Response to Dublin City Council Opinion

**In respect of an LRD Application for
Permission for the Provision of a Mixed-
Use Student Accommodation &
Commercial Development at a c. 0.962 Ha
Site at Gowan House, Carriglea Business
Park, Naas Road, Dublin, D12 RCC4**

Submitted on Behalf of Malclose Limited

November 2023

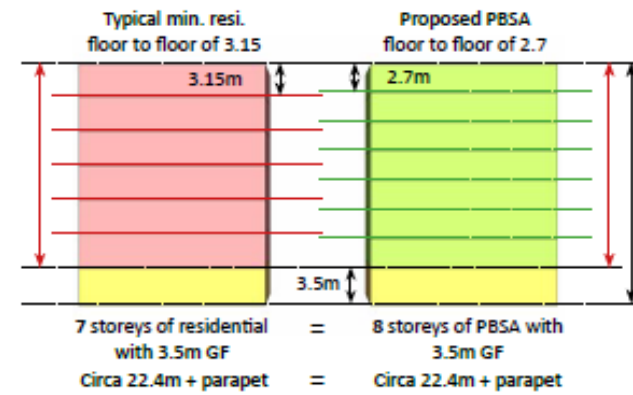
No.	Item to be Addressed	Response
1. PRINCIPLE OF DEVELOPMENT		
1	<p>Further consideration and / or justification of the documents as they relate to compliance with local planning policy to address significant material issues of concern regarding the suitability and viability of this location for the provision of a large number of student accommodation units.</p> <p>Policy QHSN₄₅ of Dublin City Development Plan 2022-2028 supports the provision of student accommodation “<i>on campuses or in appropriate locations close to the main campus or adjacent to high-quality public transport corridors and cycle routes</i>”. In assessing applications for purpose built student accommodation the planning authority will have regard to the location in terms of access to university and college facilities by walking, cycling or public transport.</p> <p>This proposed development site is not located on a campus, close to a main campus or in the inner city. The site is remote and significantly outside of walking distance of any university or college facilities and their related services & infrastructure. The local area is in need of regeneration and consequently lacks the necessary amenities and services to support the significant number of student accommodation units proposed. Overall, it is not considered that the site is suitable nor viable for student living and its associated travel patterns.</p> <p>The submission that the future Bus Connects emerging route network would enhance the connectivity of the site with the surrounding area is noted. However, the Bus Connects project at this location requires significant infrastructural upgrades. This development is at an early stage has yet to undergo a number of statutory processes and therefore can be</p>	<p>Please see a detailed response to this Item in Section 3.0 of the Planning Report and Statement of Consistency, demonstrating why the site is eminently suitable for the provision of Student Accommodation.</p> <p>In summary:</p> <ul style="list-style-type: none"> • Student Accommodation is ‘Permitted in Principle’ on the site’s Z1₄ Zoning Objective in the recently adopted Dublin City Council Development Plan 2022-2028, with Student Accommodation only permitted in principle in two other DCC zoning objectives. • The subject site is located within 150 metres of a Luas stop- the highest quality public transport available in the City. The Bluebell Luas stop provides direct access for students to TU Dublin in Tallaght, the City Centre Campuses and further public transport options for campuses such as DCU and UCD. It has been clearly demonstrated in the public transport capacity study that there is adequate capacity on the red-line Luas and on local bus services to serve the proposed development. • The accommodation’s location would suit students in the proximate Ballyfermot Further Education campuses which is renowned in the Country for its media, music and radio courses, drawing students from all over the Country. • The site is proximate to many Hospitals including notably St James’ Hospital, Tallaght Hospital and Crumlin Children’s Hospital. Thus, this will provide proximate accommodation for Student Nurses and Doctors who will be working in these facilities as part of their training. • The City Edge Strategic Framework (CESF) within which the site sits expressly supports the provision of Student Accommodation in this area as does policy QHSN₄₅ the Dublin City Development Plan which expressly references sites

<p>afforded limited material determining weight in terms of deciding whether the site is suitable for the provision of 980 student accommodation units.</p> <p>The site forms part of the Naas Road SDRA 5, which sets out sets out guiding principles for development along the Naas Road as part of the future City Edge project. The key vision of these Plans is to create sustainable successful communities. The proposed student accommodation use, which is transient in nature, would not contribute to the provision of a sustainable community as envisaged by the Plan Policy context. Furthermore, the potential for short term tourist accommodation outside of term time as per the definition of student accommodation under the Planning and Development (Housing) and Residential tenancies Act 2016, and the lack of local tourist amenities to serve the same, is also a concern.</p> <p>Having regard to the above, the planning authority considers that the site is not suitable for the provision of such a large number of student accommodation units should be developed for residential purposes as envisaged by the City Development Plan.</p>	<p>beside high-quality public transport, such as the subject site as suitable for Student Accommodation.</p> <ul style="list-style-type: none"> • By providing accommodation outside the prime City Centre location, more affordable accommodation can be provided for students. • The CESF notes that the area's <i>population generally falls below both State and wider Dublin City in terms of educational attainment (for e.g. at Upper Secondary and Third Levels) and that the provision of a greater range of employment opportunities in the area can help open up awareness of career opportunities and stimulate improved education achievement. The CESF proceeds to state that the presence of new education facilities can also increase engagement in education at both school and post-school ages.</i> There are no other Student Accommodation facilities around this area and similar to the presence of education facilities, the introduction of Student Accommodation into the area can have the same effect of encouraging greater participation in third-level education. The new residential developments granted permission in the surrounding area will include a range of unit sizes to facilitate young couples to growing families and through the effect of the visibility of students living and working in the immediate area, people may be encouraged to progress with further education. • As there is no other Student Accommodation with the area, the proposal will provide a mix of residential typologies and a diverse population into this newly regenerating area, which is key for creating new organic communities. The proposal will introduce a tenure diversity and mix, with the students bringing a different population cohort into the area, who can work in and utilise the commercial facilities provided in the subject application and the commercial/retail facilities in the surrounding granted permissions and wider area. This will significantly contribute to the new Neighbourhood that is trying to be created on these former industrial lands. <p>It is clear that the subject development will be a positive addition to the area and will enhance legibility and activate the street frontage at the subject location. Having regard to both the urgent demand for student accommodation bedspaces in Dublin City, the location of the subject site to exceptional public transport, and the</p>

<p>pattern of development in the surrounding area, which is undergoing intensive regeneration, it is considered that the subject development is an appropriate use for the site and can contribute significantly to the Naas Road and City Edge regeneration lands.</p>
